DETERMINATION OF COMPLETENESS AND  
TECHNICAL ADEQUACY

U. S. STEEL MINING CO. RESPONSE

GENEVA MINE

August 24, 1983

# GENEVA MINE TYPICAL DIVERSION DITCH CROSS SECTION

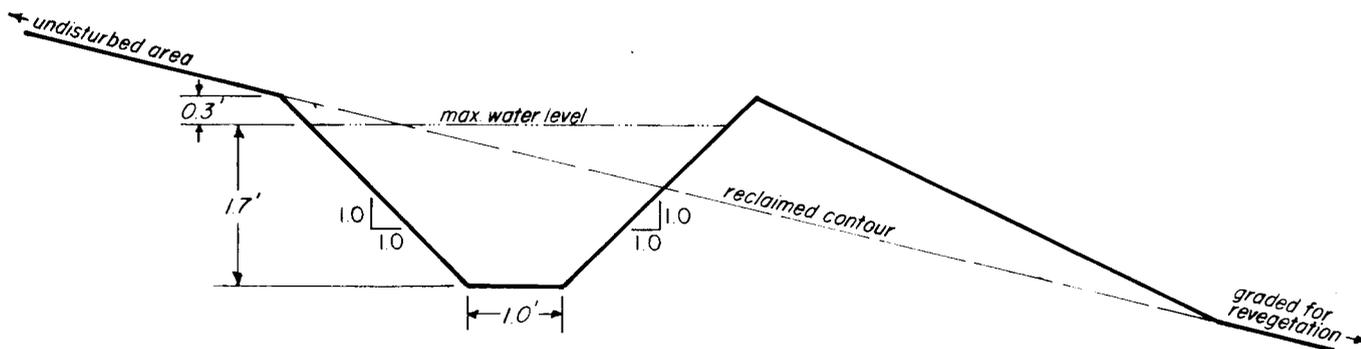
Each ditch will be constructed at the contact between the disturbed area and the undisturbed hillside. As such, all runoff into the ditch will be from undisturbed areas, but the ditch itself will be constructed on currently disturbed land (reference Drawing A3-1436).

1. Grade and compact the disturbed area according to the methods described in the MRP to the reclaimed contour shown on Drawing No. A3-1436.
2. Excavate the ditch in the compacted soil using spoil material to build a berm on the downstream side.
3. Compact the berm and channelway as necessary to ensure proper drainage.
4. Maintain a minimum of two feet of depth between the bottom of the channel and both the undisturbed contact and the top of the berm.
5. Line the channel with riprap or other currently acceptable stabilizing material to minimize erosion potential.

Each ditch will be built with the same cross section (reference Drawing A3-1436) but the length, and slope will be site specific. Each ditch will be two feet deep and maintain 0.3 feet of freeboard. As such, the following values will be the same for each diversion:

Road Junction Refuse Pile  
Geneva Mine  
Cross - Section - Case 3  
East Slope of Section A-A'-Drawing C3-1208

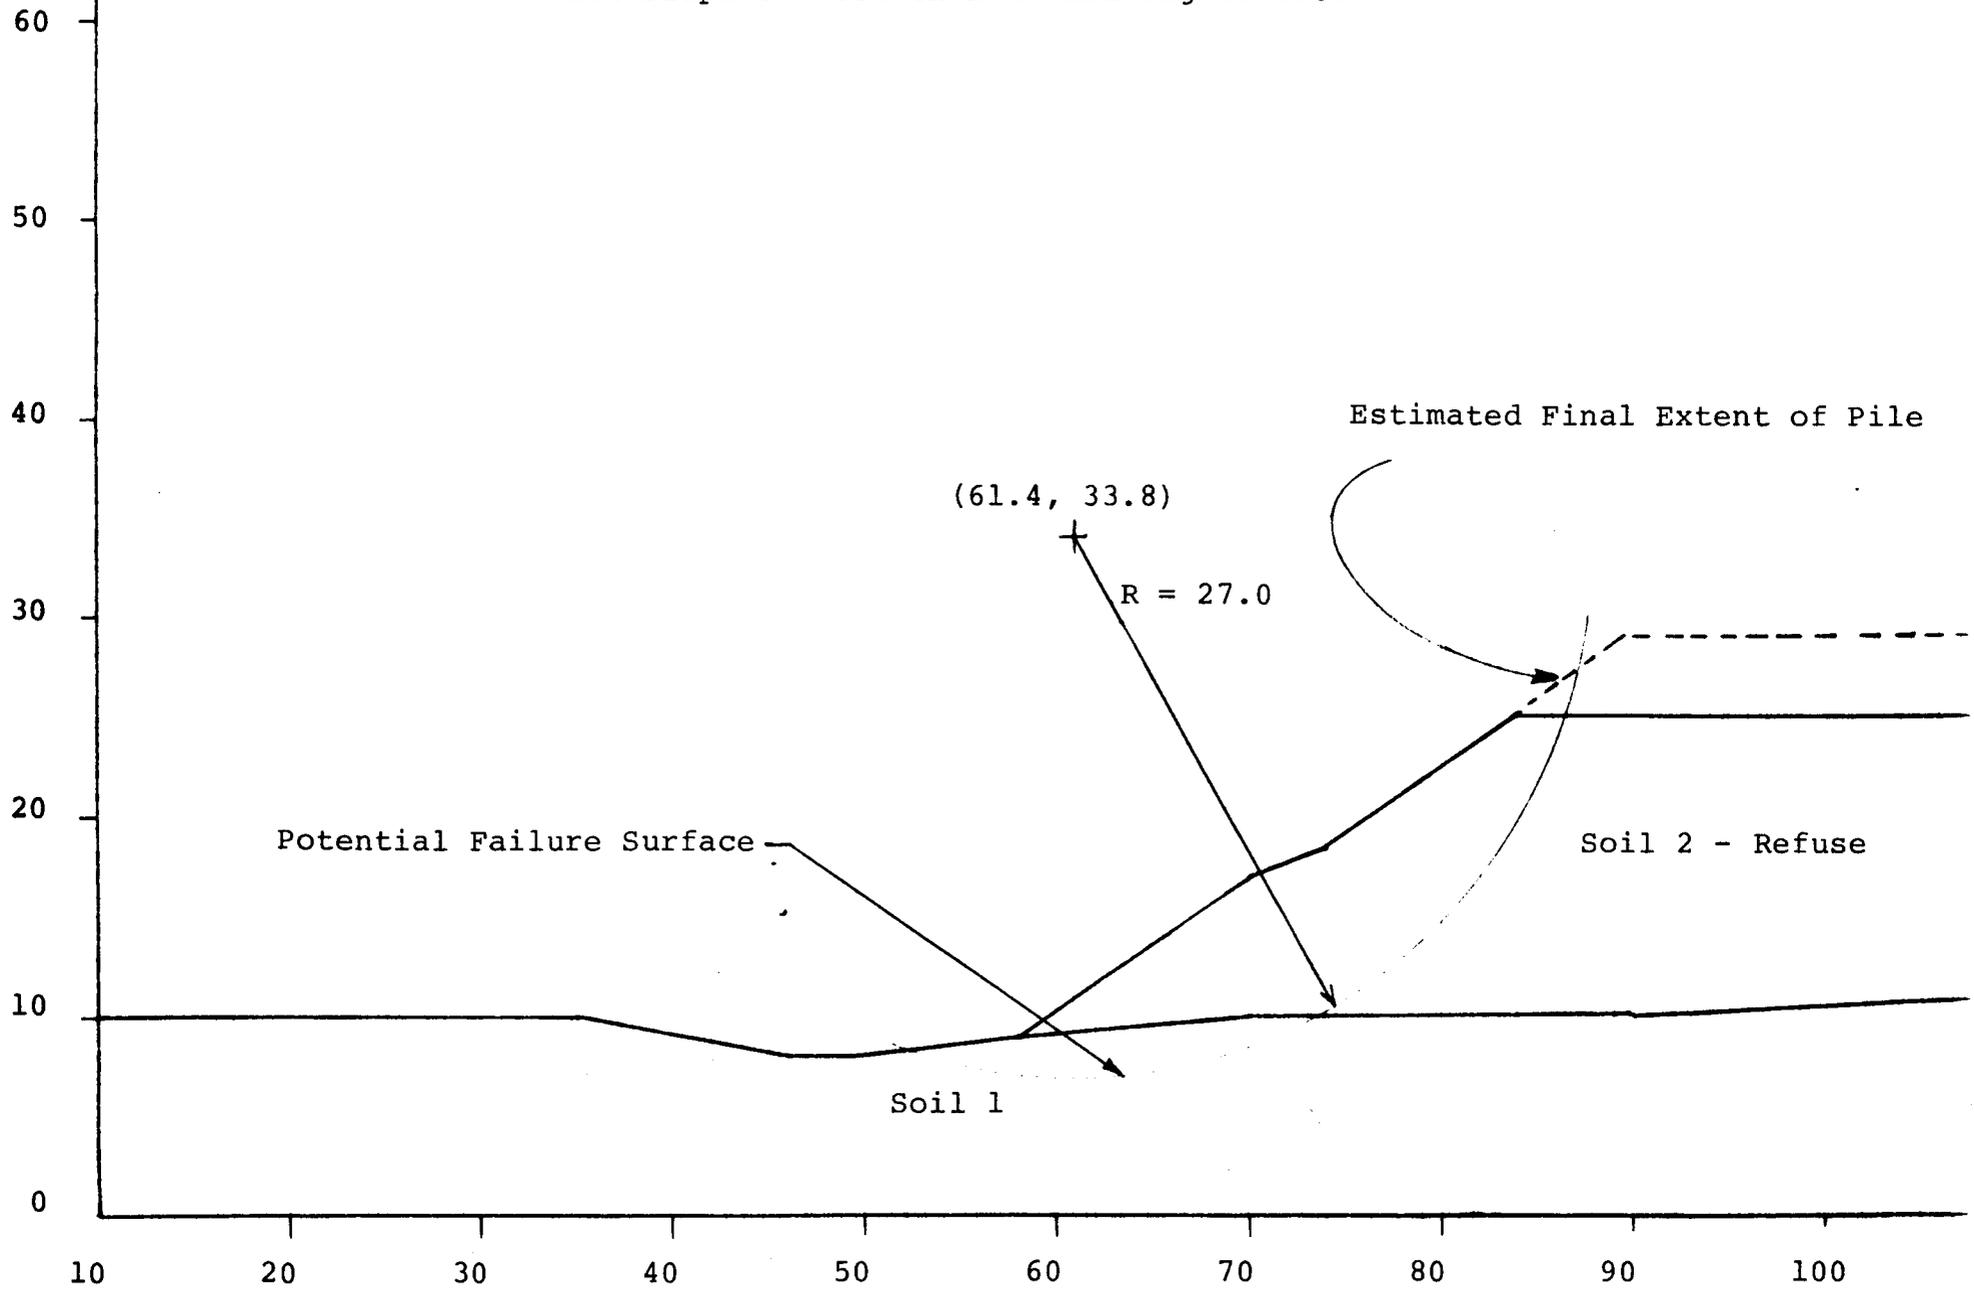
Case 3 is the east slope of section A-A' shown on Drawing C3-1208. An enlarged cross section is attached which shows the potential failure surface where the minimum safety factor was calculated. The following table lists some of the failure surfaces evaluated and their associated safety factors:

The three slopes evaluated have minimum safety factors in excess of 1.5.

Road Junction Refuse Pile  
Geneva Mine  
Cross - Section Case 1  
West Slope of Section A-A'-Drawing C3-1208

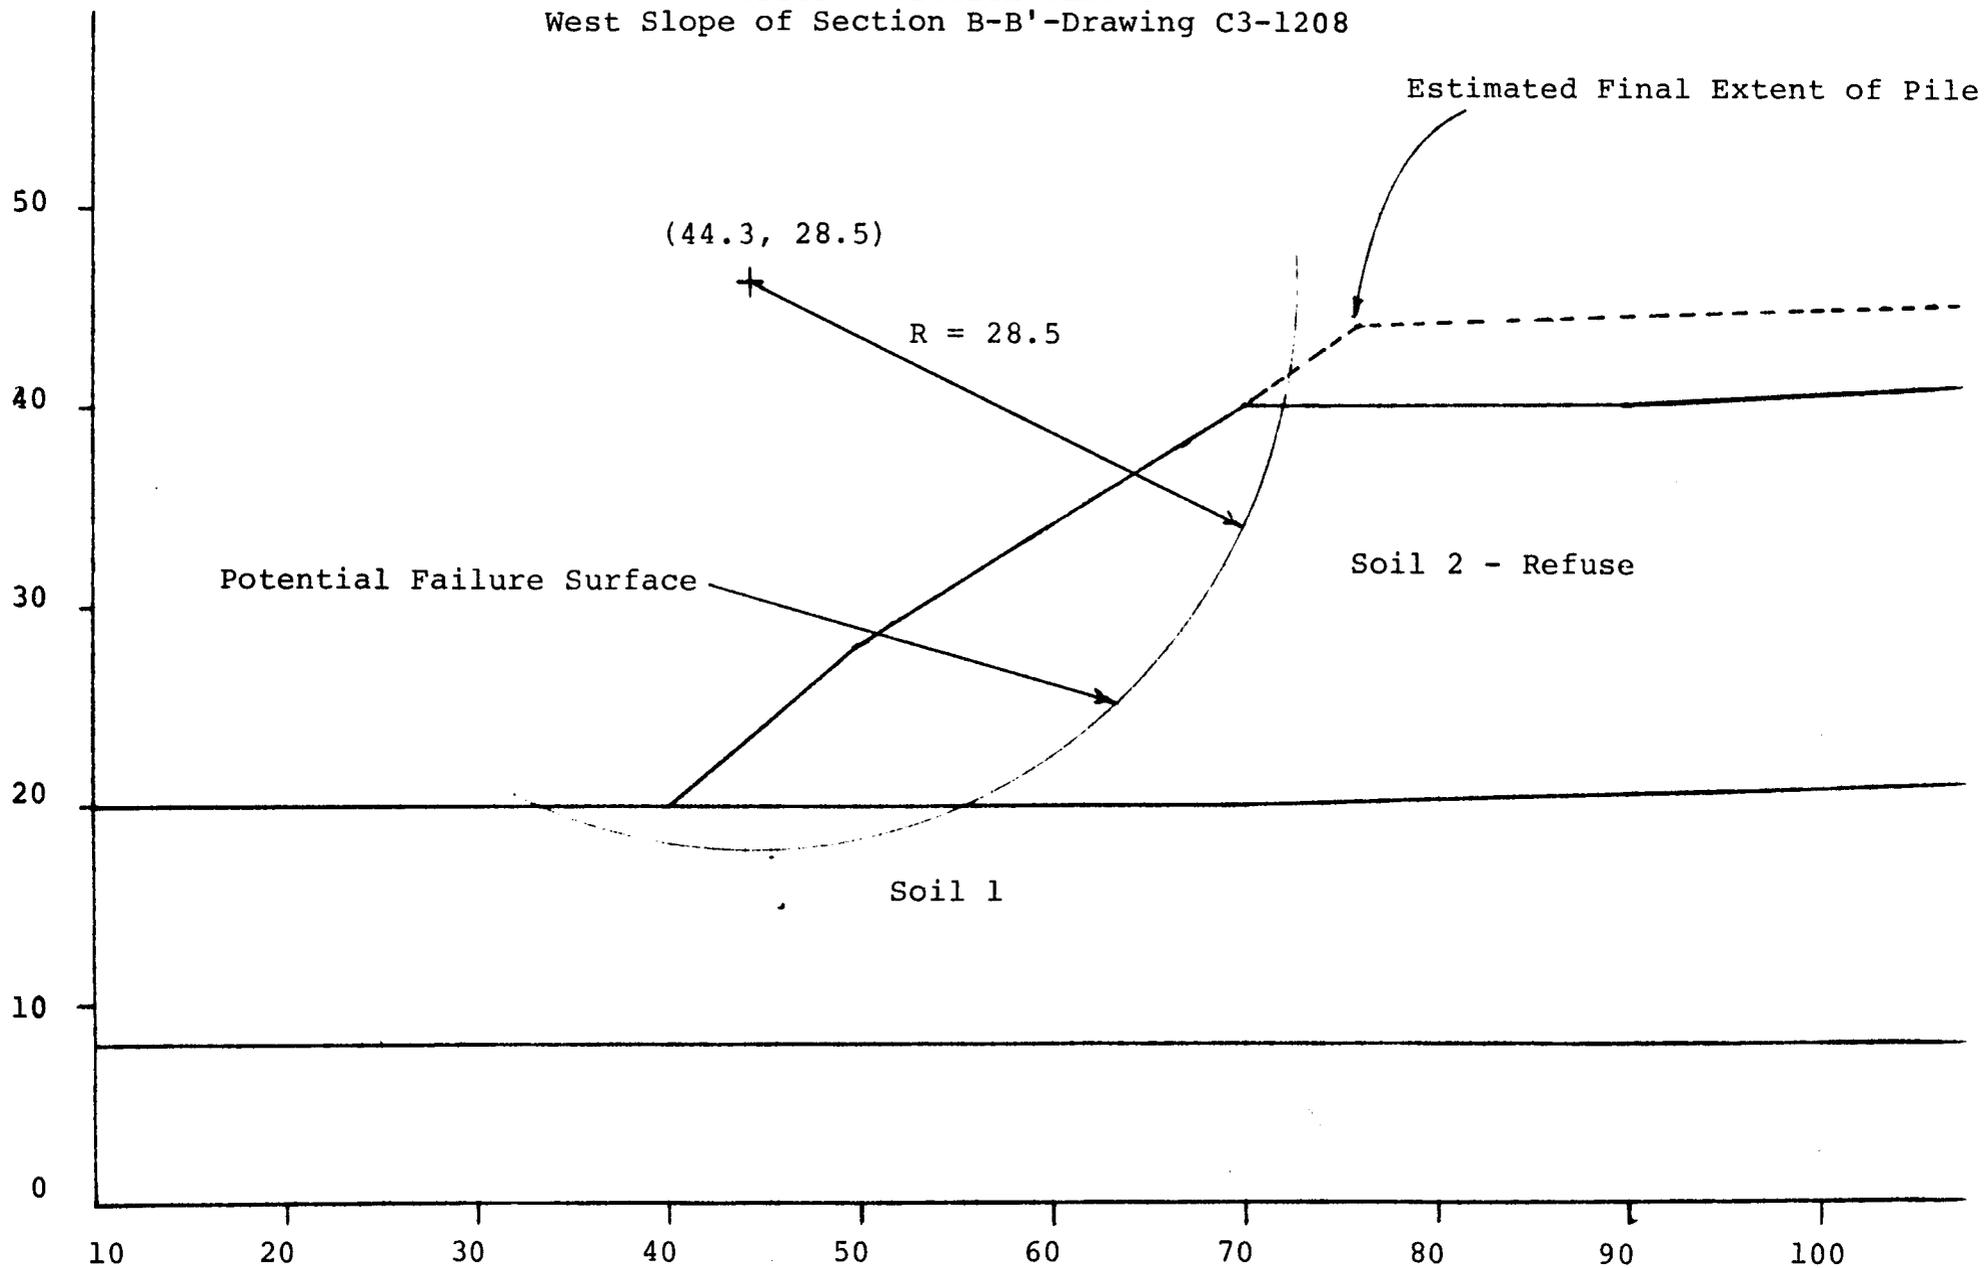
Case 1 is the west slope of section A-A' shown on Drawing C3-1208. An enlarged cross-section is attached which shows the potential failure surface where the minimum safety factor was calculated. The following table lists some of the failure surfaces evaluated and their associated safety factors:

Road Junction Refuse Pile  
Geneva Mine  
Cross - Section Case 2  
West Slope of Section B-B'-Drawing C3-1208

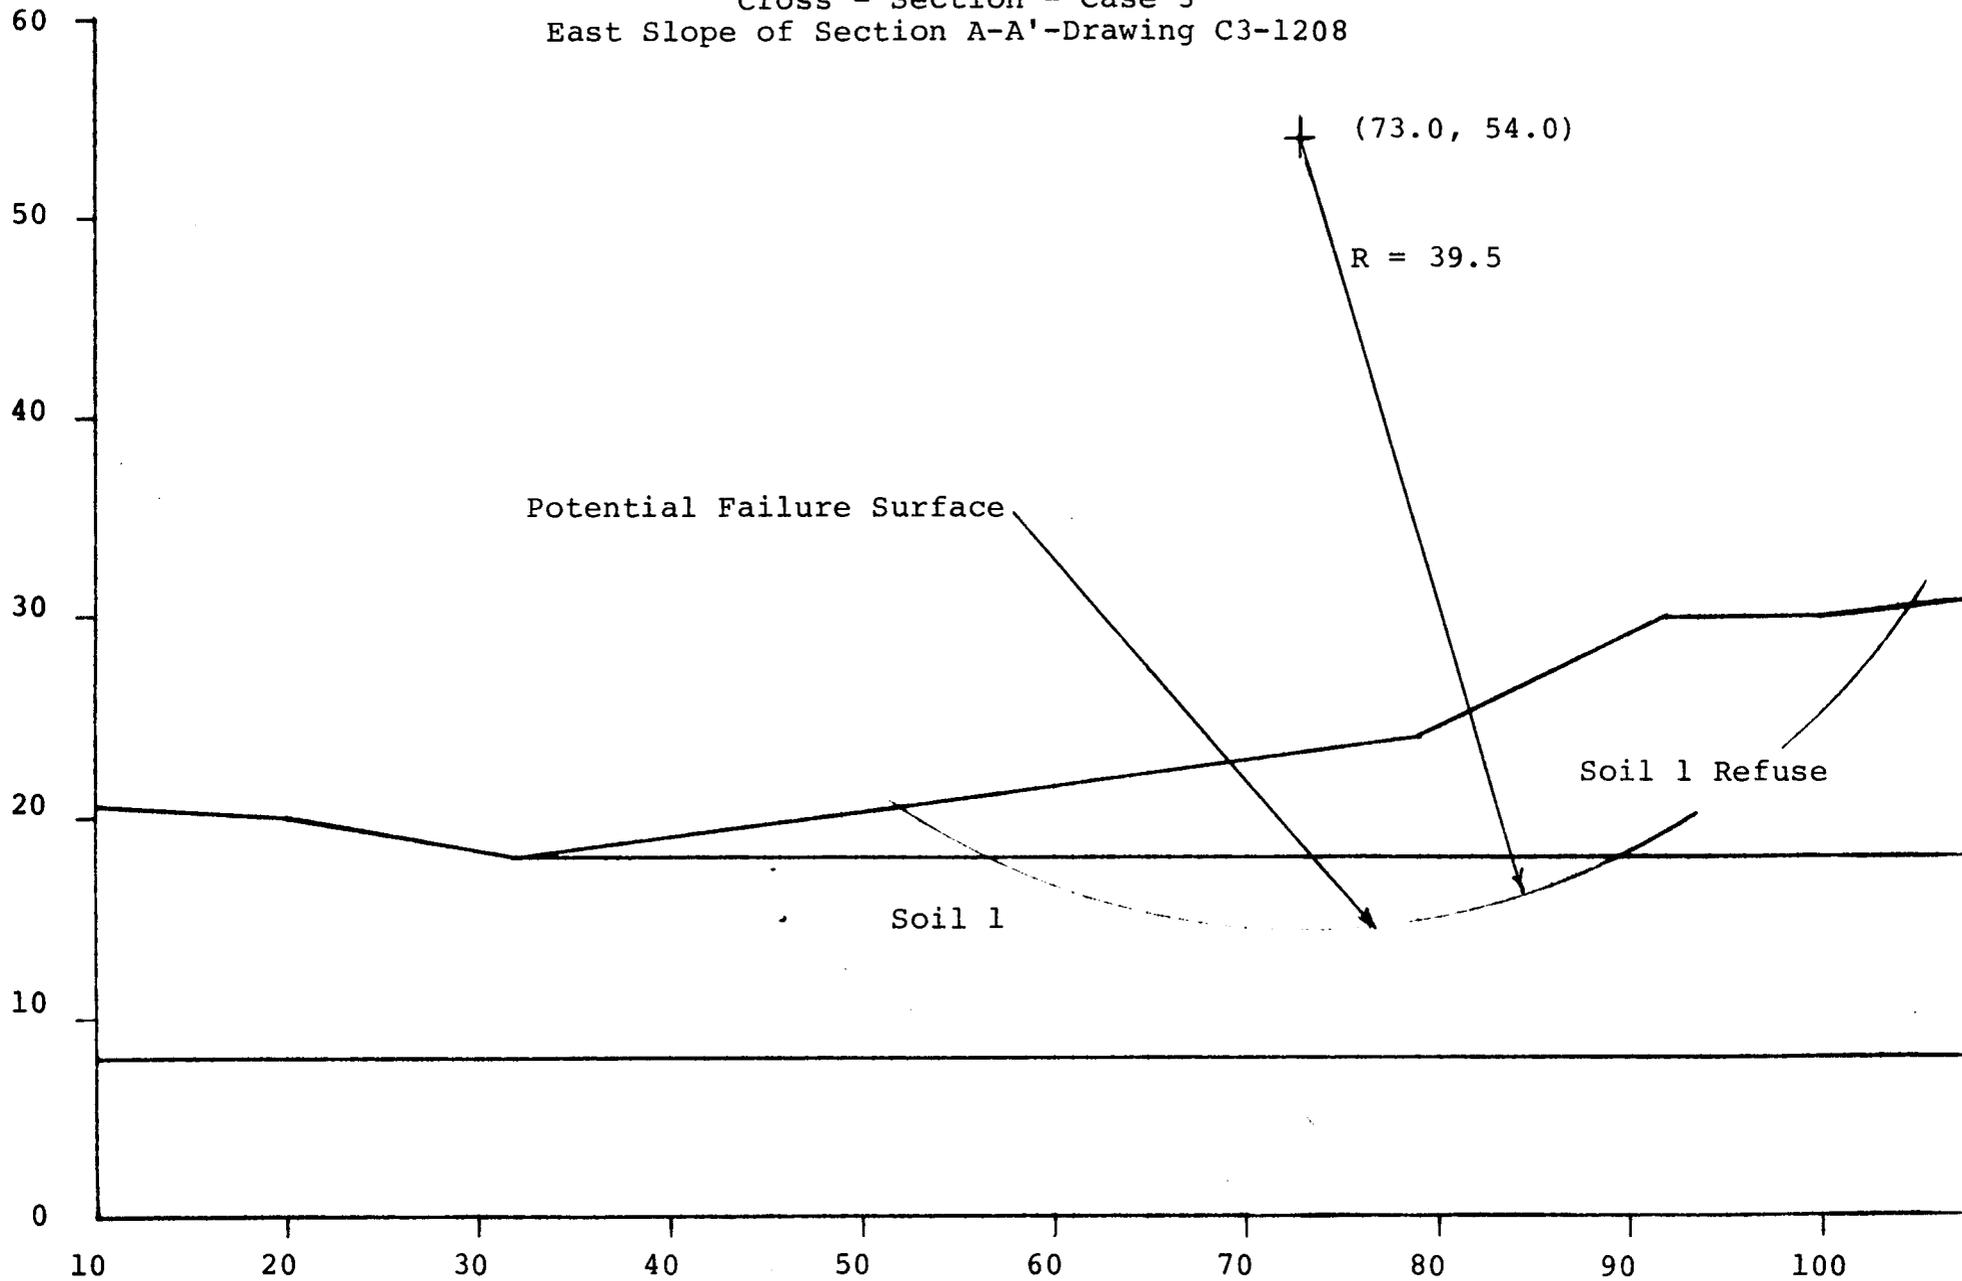
Case 2 is the west slope of section B-B' shown on Drawing C3-1208. An enlarged cross-section is attached which shows the potential failure surface where the minimum safety factor was calculated. The following table lists some of the failure surfaces evaluated and their associated safety factors:
